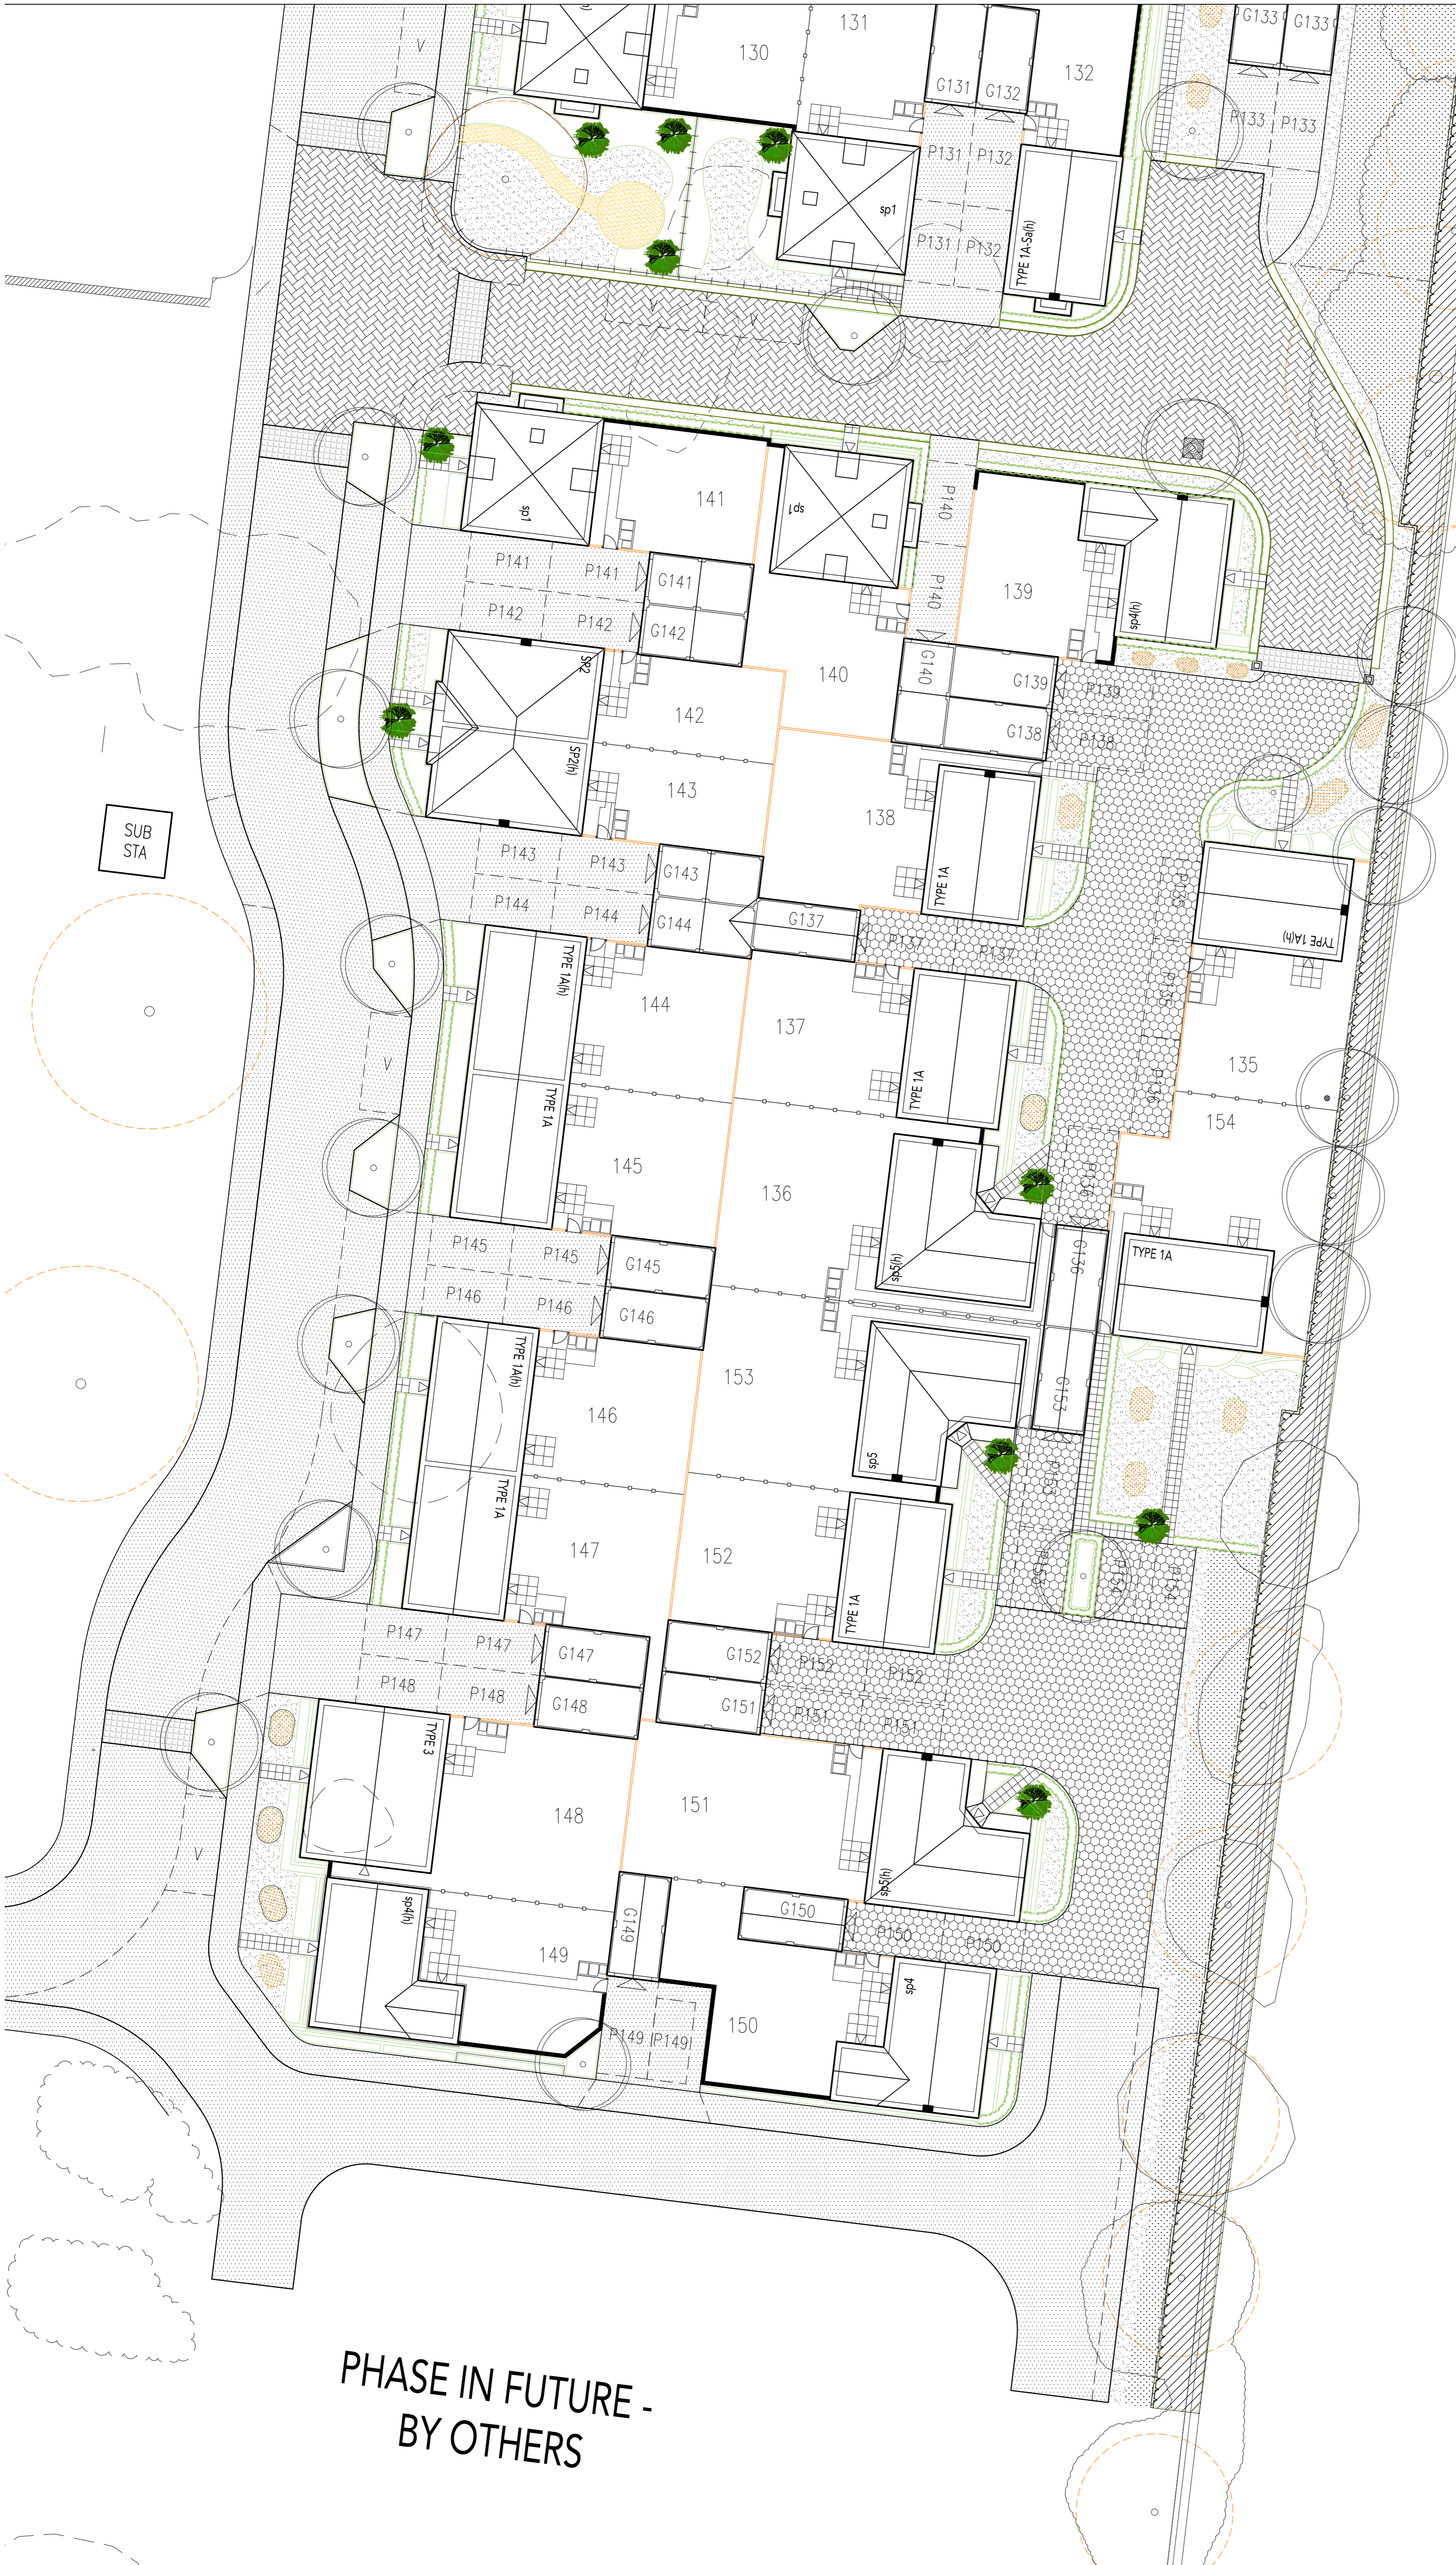
- A. 2014-10-20. Plots 9-14, 21-26 & 37-39 re-positioned and road layout in-front of those plots redesigned, sub-station relocated, gravel surface added on the private drive in front of plots 1-3 (now 105-107), shingle/stone rolled tarmac added on the private drives village green design updated, plots 6, 17, 18 swapped with type 4A and side access to plot 29 amended, Plot 20 & 36 handed and plots 1-50 renumbered as 105-154 to suit with other parcels following Local Authority's comments. SRS

- B. 2014-10-29. The frontal projections on plots 114-117, 126-129, 142 & 149 made 300mm wider, garages for plots 115-118, 125-130, 141 & 42 made eaves fronted, roof form on plots 112-114 changed, plot 139 re-aligned and plot 109 handed following Local Authority's comments. SRS

- C. 2014-11-11. The footprints for SP1 on plots 113, 118, 125, 130, 131 & 141 made 350mm wider & deeper, plots 119 & 124 repositioned and the extra visitor's space in front of plot 113 taken off, following client's request. SRS

- D. 2014-11-23. Plot 122 is re-positioned & substituted with a SP5, plot 138 is substituted with a Type 1A, plot 140 is substituted with a SP1, plots 134 & 154 is substituted with a rear version of Type 1A and necessary layout amendment carried out following these amendments, as per Local Authority's comments. SRS

- E. 2014-12-05. Plots 122, 133-135, and 154 repositioned to avoid existing trees at Tree Officer's request. DJE
- F. 2015-01-09. Title amended to Phase 3 from Phase 2 at clients request. AJA

- G. 2015-01-23. Bay window removed from house type 4A. Block Paving specification added. Loose stone grid system added in lieu of stone rolled tarmac. All at client's request. DJE

- H. 2015-02-18. Display of Close Board Fence amended at client request to improve clarity. DJE
- I. 2015-02-24. 1500mm high post & rail access gate added to the managed vegetation area at the eastern boundary, 1500mm high extra post & rail fences added along the plots to the eastern managed vegetation area and boundary extend for plot 134 extended while removing the screen wall and adding 1500mm high post & rail fence along the eastern managed vegetation area, following client's request. SRS

- J. 2015-04-07. Paved areas in front of plots 118, 125 and 141 amended, appearance of tarmac hatching adjusted, 1800mm high pier amended and low wall removed in front of plots 148 and 149 all at client request. MED

- K. 2015-06-05. Legend updated to indicate patios as 450x450 Marshalls buff slabs. AJA
- L. 2015-10-26. Roads by Plots 118-125 and by Plots 130-134 & 139-141 widened to 8m overall. Junctions amended. All to match construction details. DJE

- M. 2015-12-03. Road by Plots 113-118 and 125-130 amended. Boundary updated. DW
- N. 2016-02-18. Landscaping updated to front of Plots 118, 125 + 141. Brick piers, rumble strip and low screen wall to Plot 121 adjusted to match as built survey received 2016.02.17, landscaping adjusted to suit. EMB

- O. 2016-02-26. Bulldozers repositioned and on-street parking spaces amended along the road west of the site. Position of the piers to the side of Plot 123 adjusted at client's request. PVA

- P. 2016-03-10. Bulldozers by Plots 114-117 added. Road alignments by Plots 130 and 148 amended. All to suit latest Woods Hardwicke scheme. DJE
